Title: Technical and editorial amendment of 802.16-2004 facilitating license-exempt and uncoordinated band operation

Document Number: IEEE S802.16h-06_001

Date Submitted: Jan. 11, 2006

Figure 219—Illustration of OFDMA frame with multiple zones

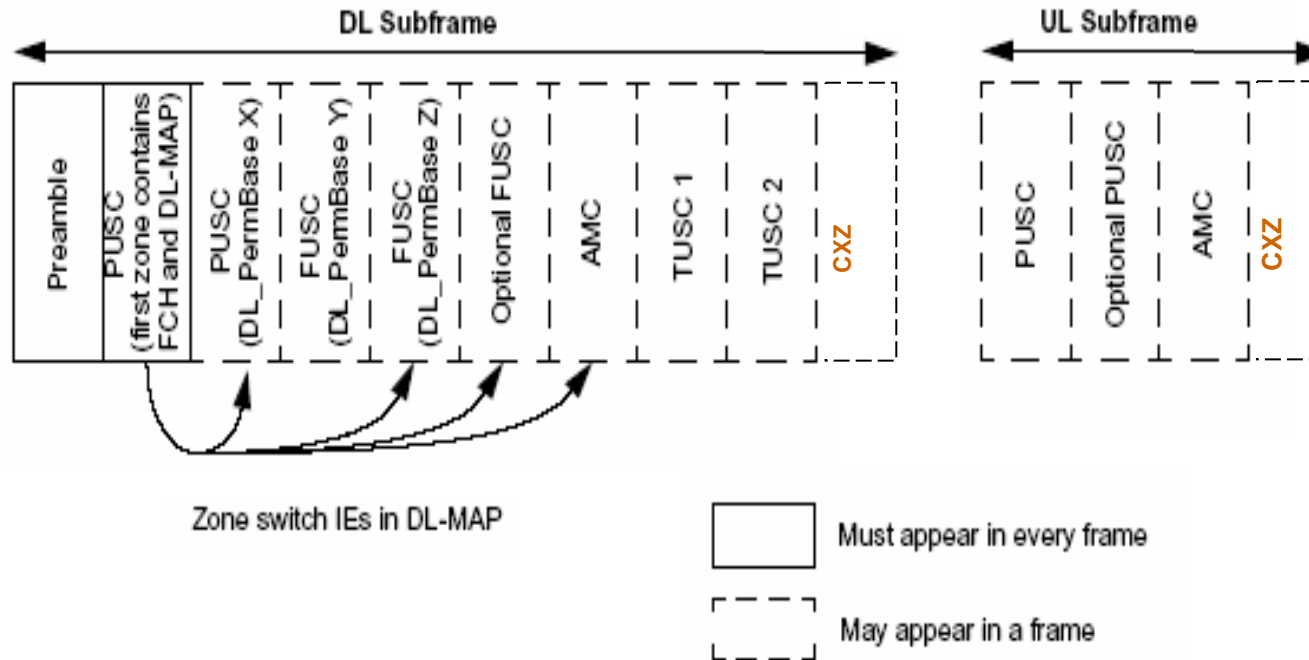
- Modify '*Extended DIUC Code Assignment for DIUC=15*' table 275a, section 8.4.5.3.2.1 for the downlink. This assigns a code for the case DIUC=15 and provides a code specification for the extended DIUC.
- Modify '*Extended UIUC Code Assignment for UIUC=15*' table 289a, section 8.4.5.4.4.1 for the uplink. This assigns a code for the case UIUC=15 and provides a code specification for the extended UIUC.
 - The DL and UL CXZ is terminated by another CXZ IE or the end of the frame.
 - Multiple CXZ zones can exist within the same frame.
- CXZ is added to the generic diagram figure 219 (Section 8.4.4.2) describing the zones supported by the standard.
